BOROUGH OF OCEANPORT PLANNING BOARD

REGULAR MEETING • AGENDA

MARCH 24, 2026 at 7:00 PM

10. **New Business**
 - 10.1. PB2026-03 Ryan Glubo
Block 52, Lot 2
62 Manito Place
Proposed semi-inground pool and patio
Maximum Impervious Coverage: 37% permitted, 34% existing, 42.4% proposed

1 SITE PLAN
1" = 10'-0"

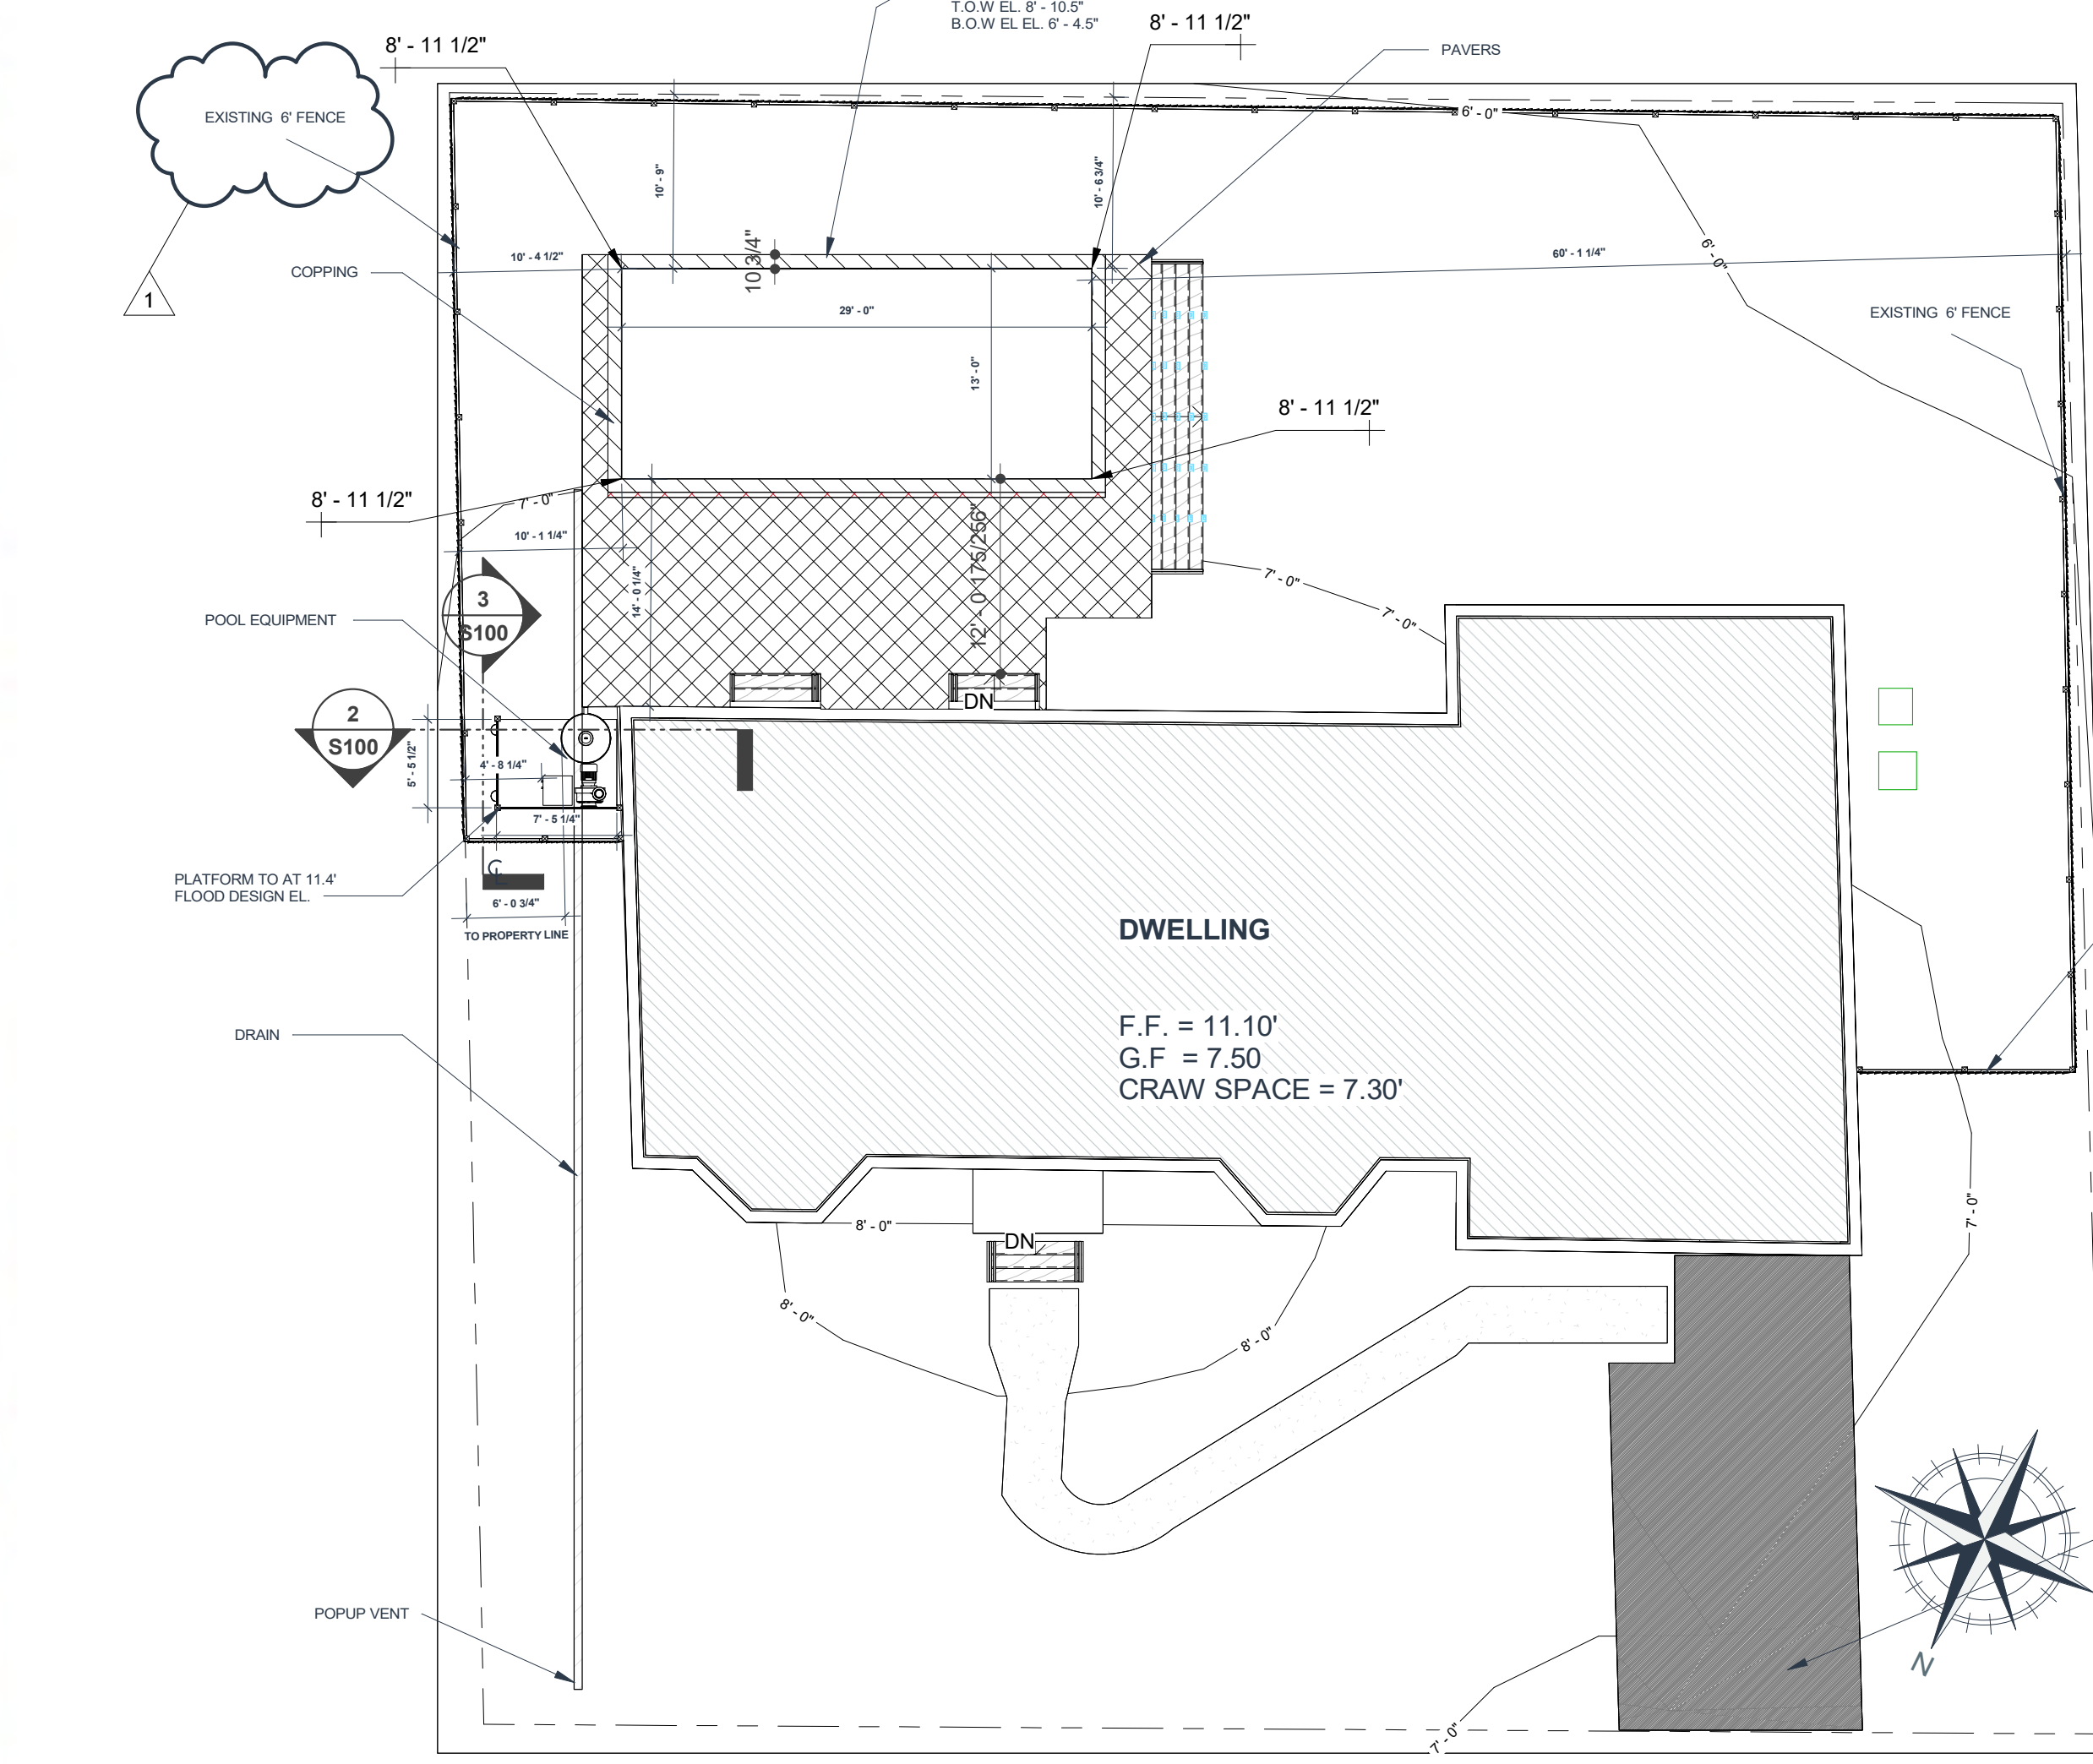
Based on our review, we recommend that the Application be deemed **incomplete** as a signed and sealed copy of the property survey was not provided and the setback of the pool equipment platform is not dimensioned on the plan. A preliminary planning and engineering review of the application is included below:

1. Bulk variances are required for the following:
 - a) Maximum Impervious Coverage – 37% permitted, 34% existing, 42.4% proposed. The site will exceed the coverage limit by 535 square feet.
 - b) Pool Equipment Setback – a minimum 10-foot setback is required (390-31G), the setback from the side yard to the equipment platform is not dimensioned on the submitted plan.
 - c) Fence Height – maximum fence height of six feet is permitted (390-25A(1)). The top of the fence on the platform is approximately seven feet above grade.

6. The platform for the pool equipment appears to be twice the size that is needed. Applicant shall clarify the need for the oversized platform as it encroaches into the required 10 foot setback.

STATUS: PROPOSED
 BUILDING DEPT PERMIT NUMBER:
 HLS Project number: 202520
 DRAWN BY: Author
 SHEET NAME: GRADING PLAN
 SHEET NO: GR001
 Scale: As indicated

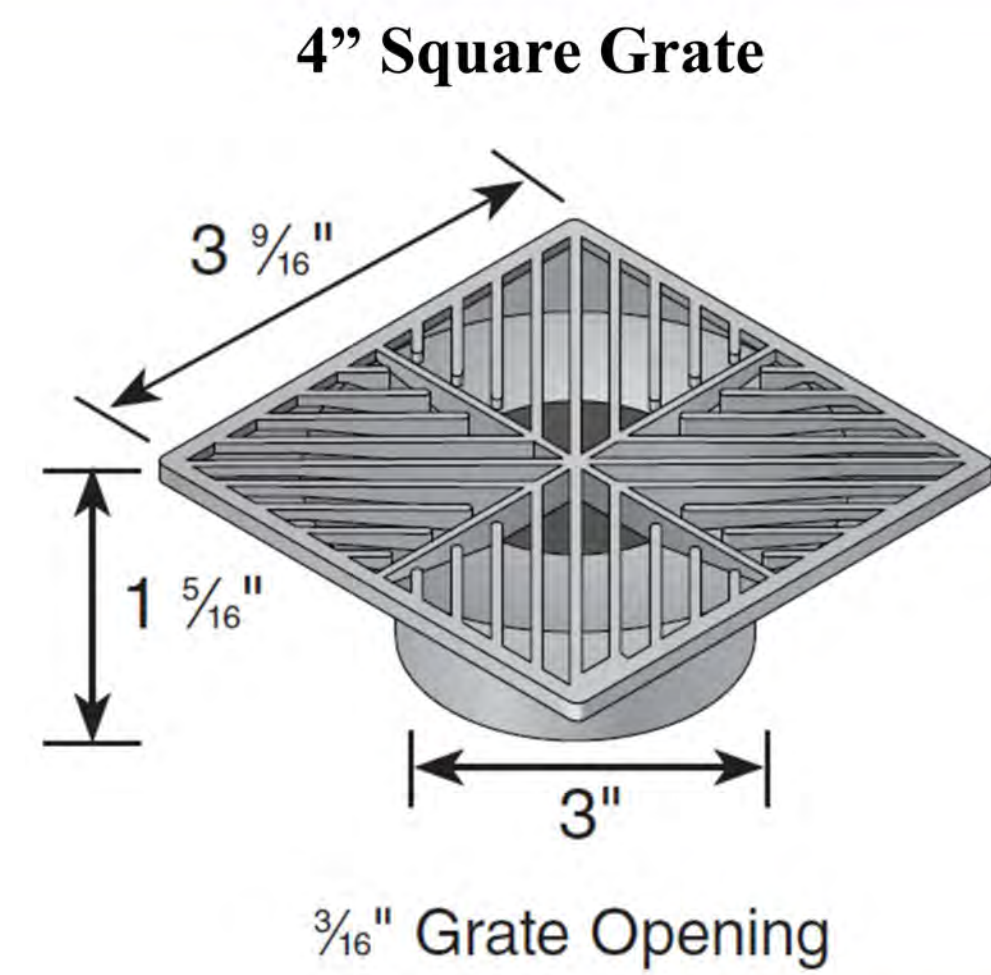
7. The Grading Plan, sheet GR001, only provides the proposed elevations of the four corners of the pool, which is insufficient to perform a grading review. Additional proposed grading information shall be provided to include but not limited to elevations of: top of wall, bottom of wall, finished floor elevation of the dwelling, spot grades along the dwelling, stair elevations, trench grate elevations and spot grades for any changes to the lawn areas.
